PD Modification Application: PRS 26-0008

**Hillsborough
County Florida**

Development Services Department

The applicant is requesting a minor modification to reduce the front yard setback for garages and add an additional access onto County Road 579.

2.4 Proposed Site Plan (partial provided below for size and orientation purposes. See Section 8.2 for full site plan)

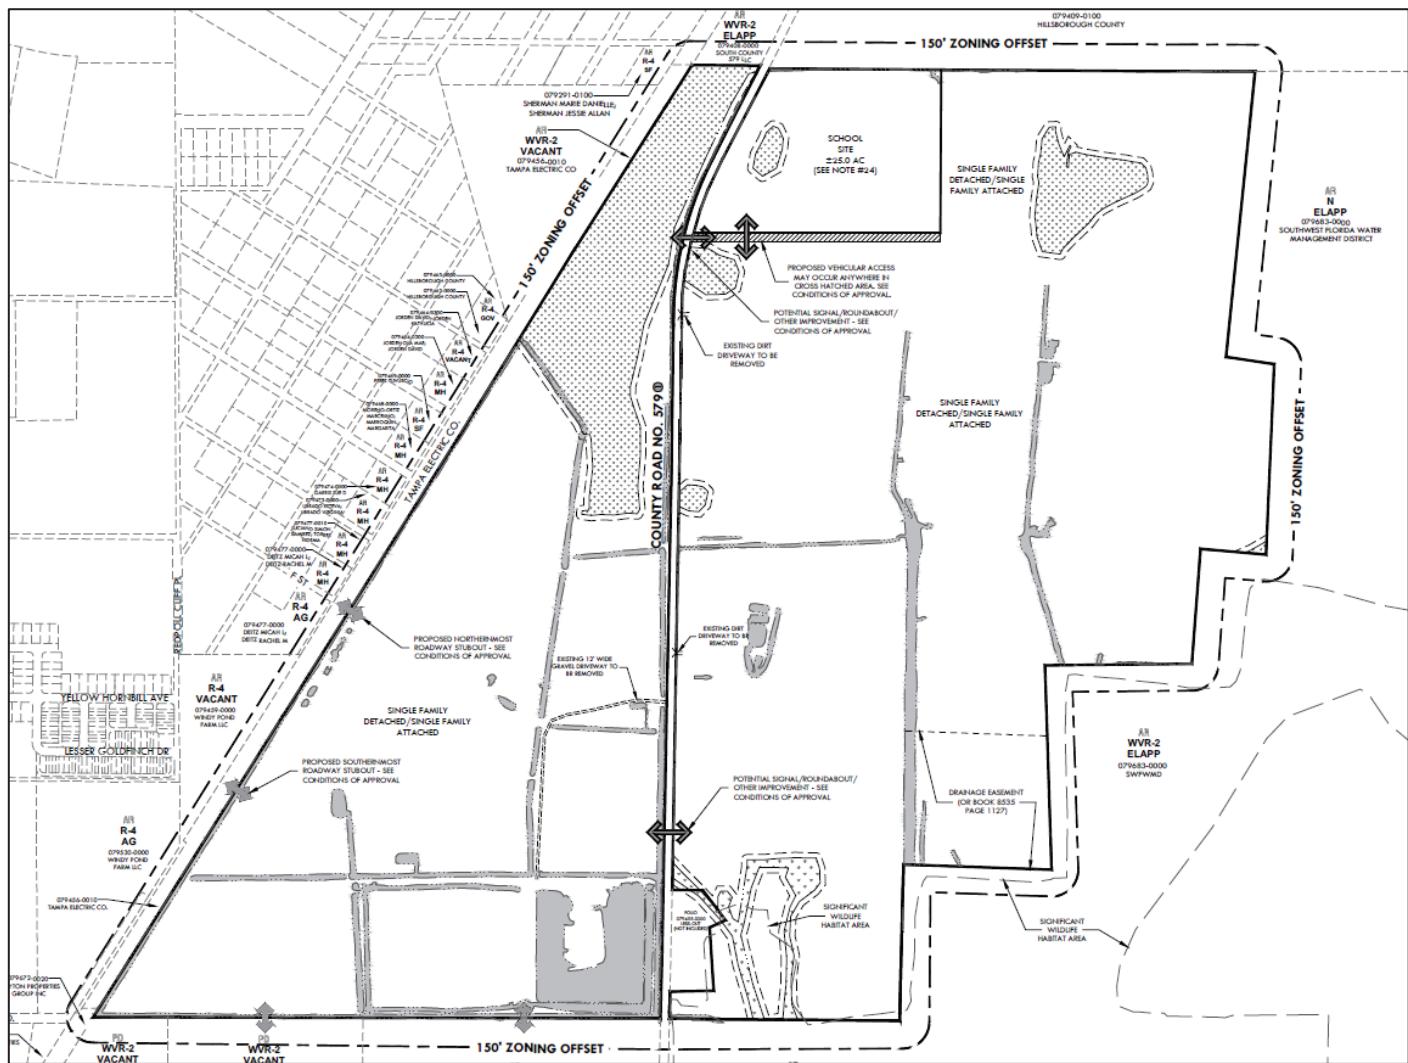
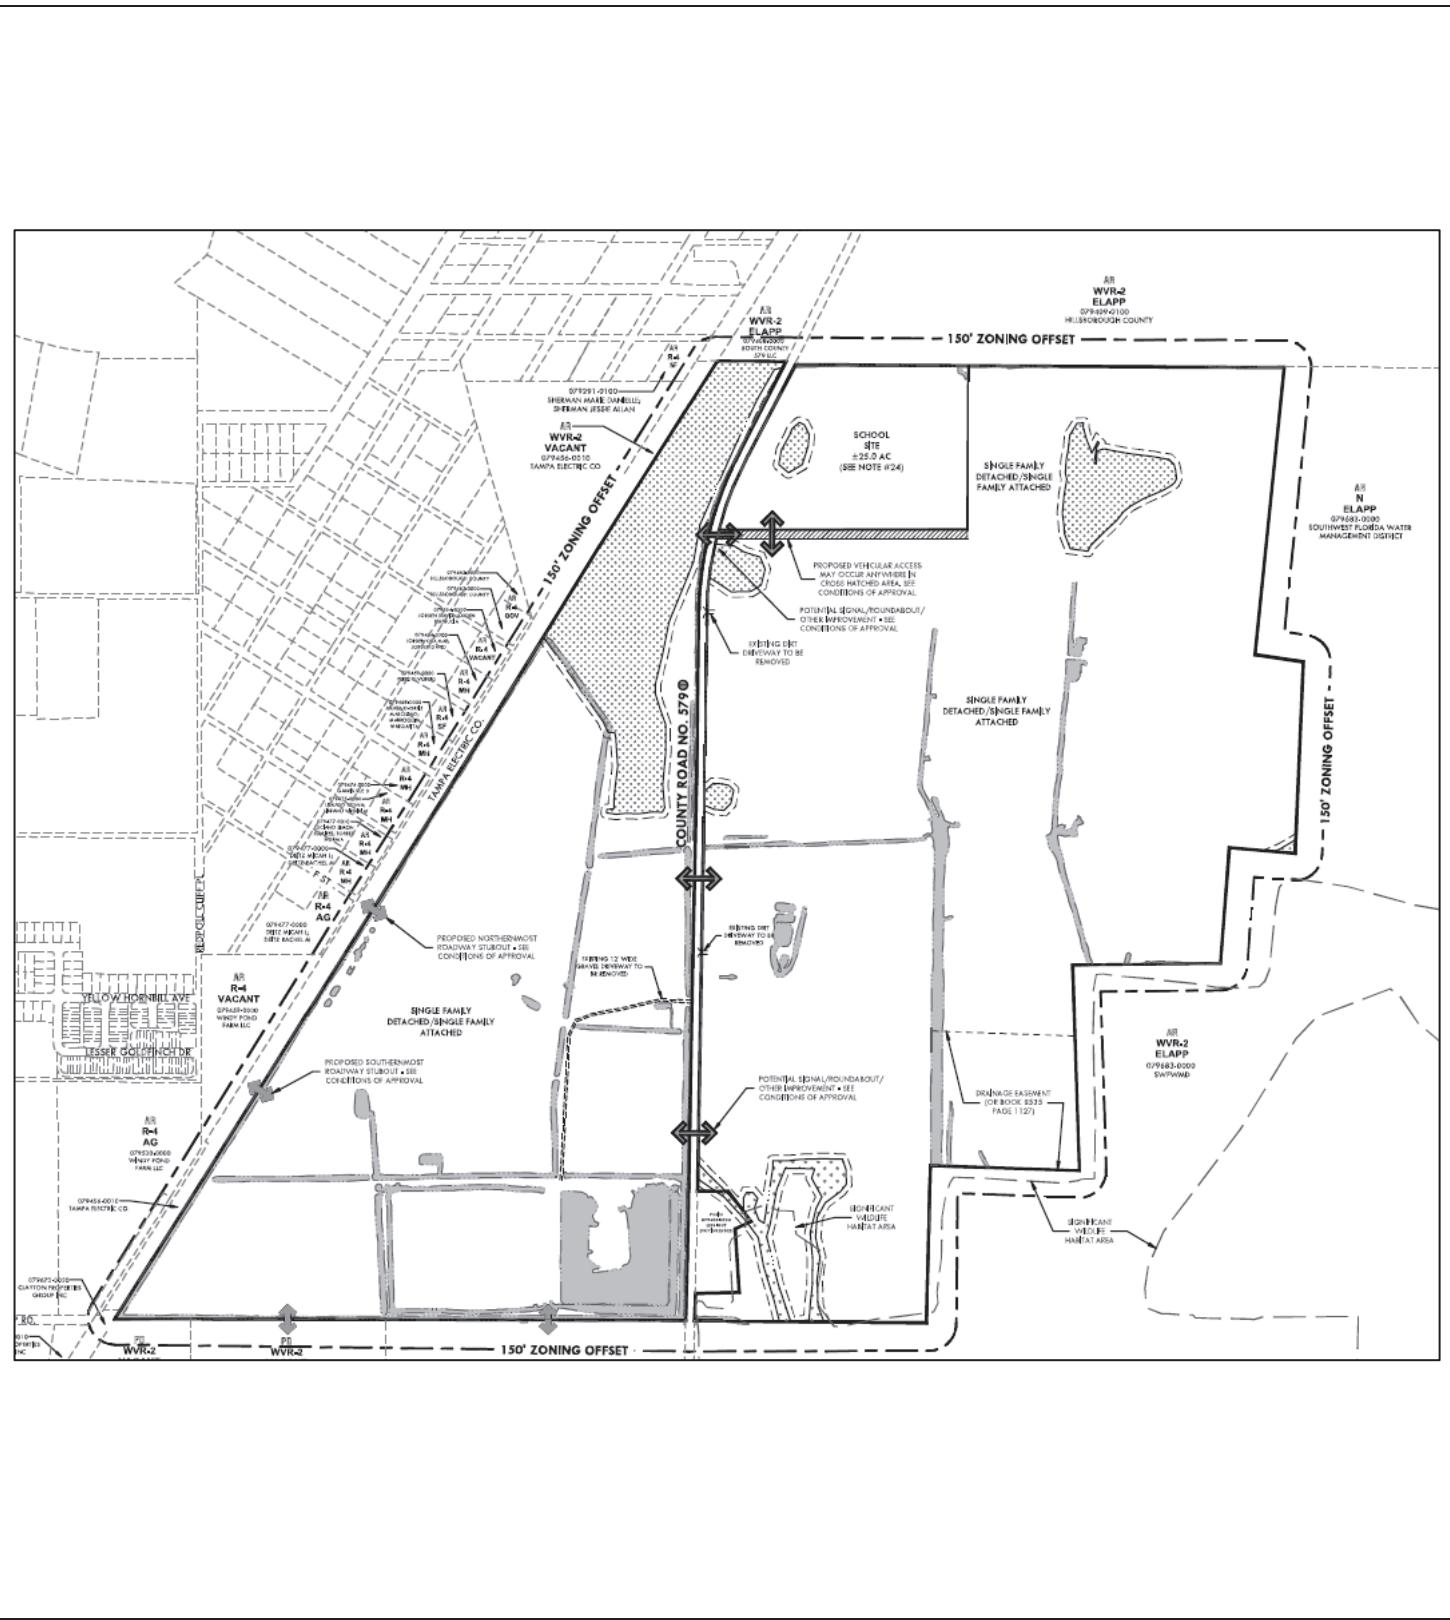
The applicant looks to modify Planned Development 25-0469 by amending the single-family home development standards by reducing the front yard setback for garages from 25 feet to 20 feet. Applicant also seeks to add an additional access along CR 579.

Staff does not have any compatibility concerns with the requested modifications.

SITE ACCESS AND CONNECTIVITY

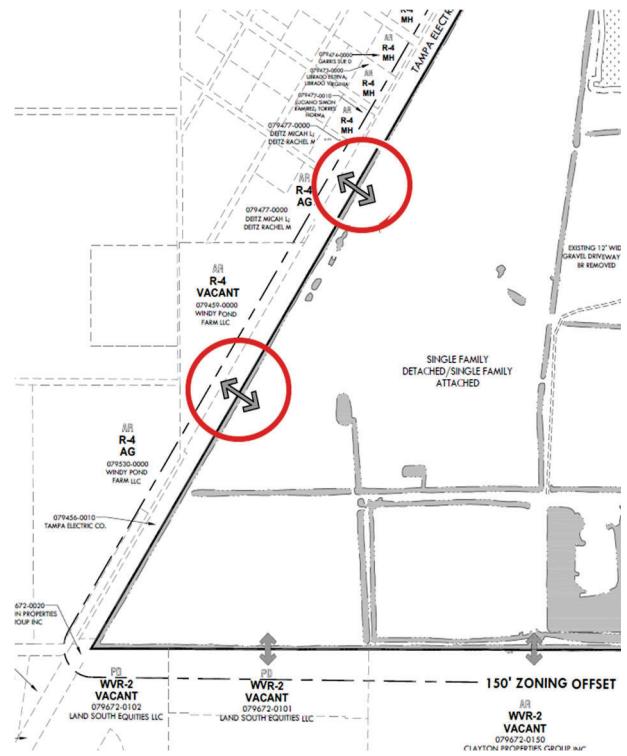
The applicant is proposing to take access to the project via CR 579. One additional access connection is proposed to be added by the applicant for this PRS. A series of roadways will be constructed to accommodate internal project traffic. The applicant's analysis indicated that certain auxiliary (turn) lanes were warranted per Section 6.04.04.D. of the LDC; however, intersections may be required to be signalized. If signalized, auxiliary turn lanes would need to be constructed; however, if the developers choose to pursue installation of roundabouts, auxiliary turn lanes may no longer be needed. As such, staff has deferred the determination of auxiliary turn lanes to the site/construction plan stage. The developer will be required to analyze the need for site access improvements, based on whatever intersection control devices are ultimately warranted, and may be required to install dual lefts into or out of the site depending upon the final type/amount of development and configuration/design of proposed intersections and access control devices. Staff notes that dual receiving lanes or other similar improvements could be needed. Also, if turn lanes on one leg of an intersection are required, the County will require a turn lane on the opposite leg regardless of whether such turn lane is strictly warranted pursuant to Sec. 6.04.04.D. County staff has ensured that access locations as well as the proposed conditions will work together to minimize external impacts from the potential school site to CR 579 to the greatest extent possible.

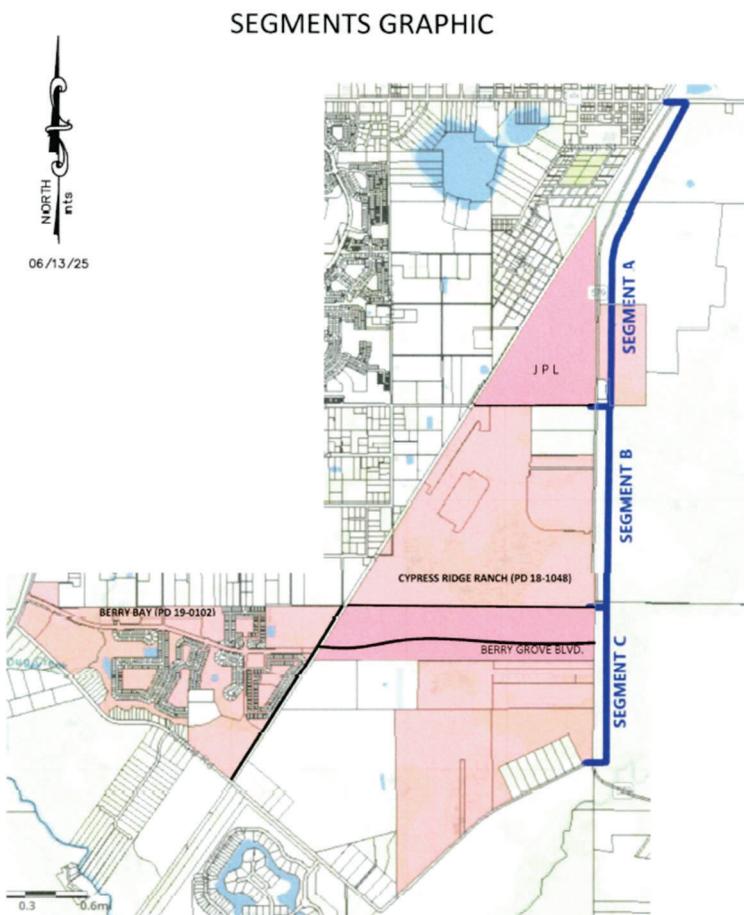
- In lieu of the 8-foot-wide shoulders (of which 5 feet is paved) typically required by the TTM's TS-7, the developer will be permitted to construct 6-foot-wide stabilized shoulders (of which 5-feet is paved) within Sections A and B, and 5-foot-wide paved shoulders within a stabilized shoulder of indeterminate width within Segment C.

- In lieu of 7-foot-wide buffered bicycle facilities along both sides of the roadway, the developer will be permitted to install a 10-foot-wide multi-use path within Segment A along the west side of CR 579 (transitioning to a 5-foot-wide sidewalk north of the project where necessary due to right-of-way constraints).

If 26-0008 is approved by the BOCC, the County Engineer will approve the deminimis Design Exception request.

--Southern Boundary--

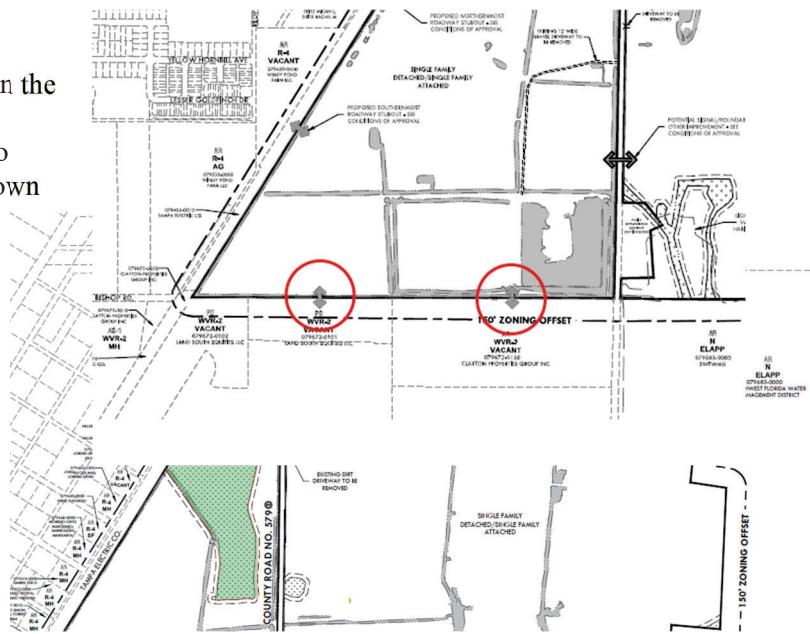
The southern property boundary is approximately 3,200 feet in length (between the TECO corridor and CR 579). Given the connection spacing standards, a total of two connections would be required (rounded down from 2.42).

The developer is providing two connections, in addition to the CR 579 north-south corridor, (for a total of three connections provided). Applicant-proposed through road connections are shown circled in red.
